ADA Curb Ramp New Construction Inspection Form (Perpendicular)

Nw 287

24952.54

Nw mays

PERPENDICULAR RAMP (PR)

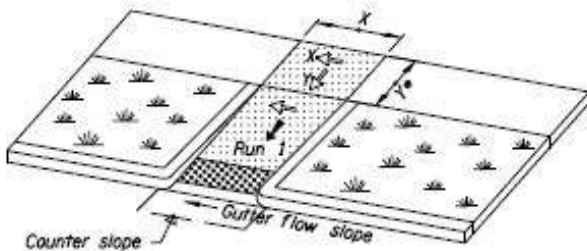
IITD RR1 fail
